HYDROX NOMINEES PTY LTD

TRANSPORT ASPECTS OF  
PLANNING PROPOSAL FOR  
MASTERS, BULKY GOODS AND  
INDUSTRIAL DEVELOPMENT,  
HAWKESBURY VALLEY WAY,  
CLARENDON

SEPTEMBER 2013

**PROPOSED MASTERS DEVELOPMENT  
162 – 188 HAWKESBURY VALLEY WAY, CLARENDON**

**Masters access intersection  
concept layout**

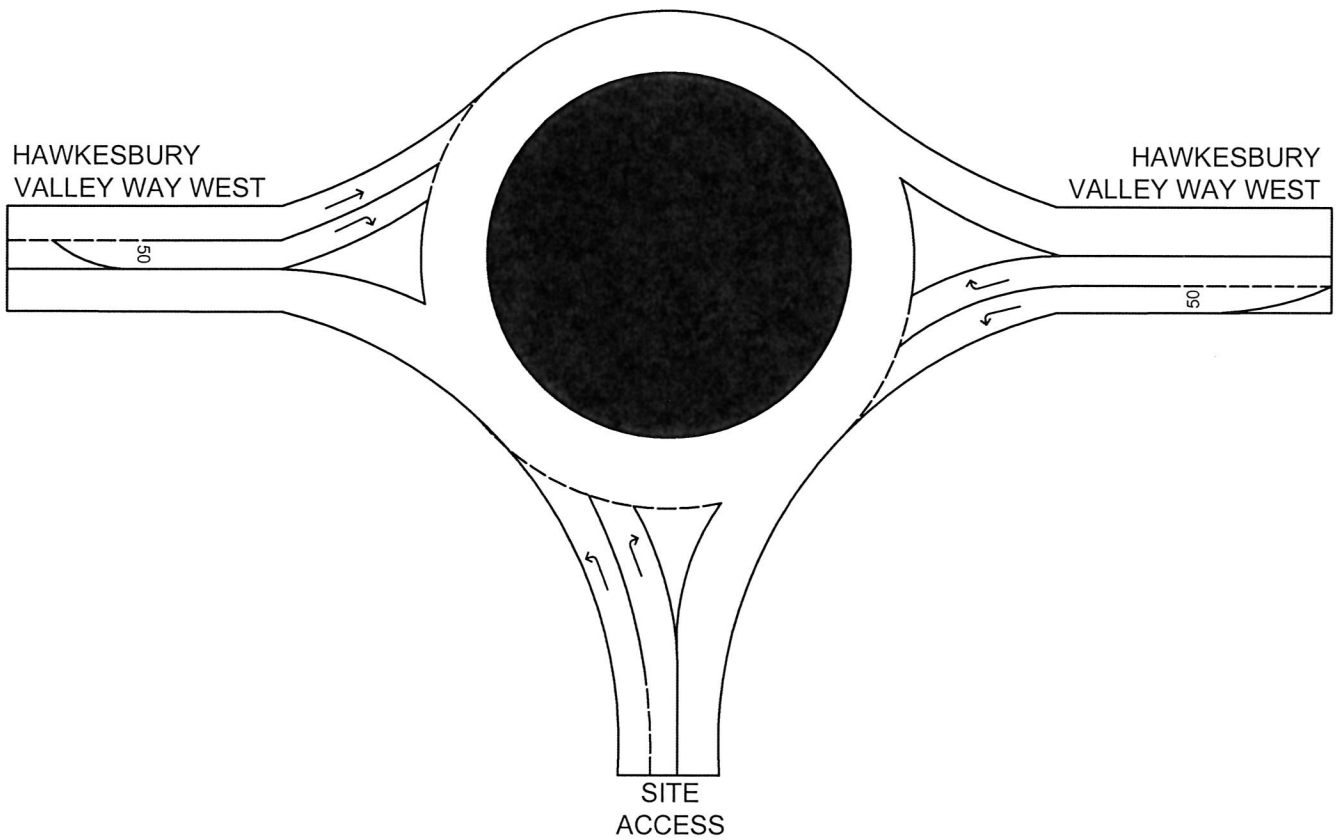
*2. RMS provides in principle support for an access road off Hawkesbury Valley Way to service the proposed development and adjacent land. The design and construction of proposed access road shall make provisions for conjoint access to the adjacent block of land. A two lane roundabout is the preferred facility at the proposed intersection. However, it is the applicant's responsibility to demonstrate that a roundabout would be the most suitable facility at this location.*

*3. The applicant is to undertake traffic modelling to determine the required turning lanes at the roundabout.*

4. *It is noted that the proposed roundabout is partly within Federal land. Any land required to accommodate the roundabout and associated facilities will have to be dedicated as public road by the applicant.*

2.53 We agree that a roundabout is appropriate to provide access to the Masters development. Two lanes are proposed on the Hawkesbury Valley Way approaches, as discussed in paragraphs 2.30 and 2.43. The second approach lanes would be 50 metres long and would be dedicated left and right turn lanes into the site.

2.54 This matter is noted. The RMS's comments relate to an earlier version of the plans for the site. Land required for the roundabout will be provided from the subject site.
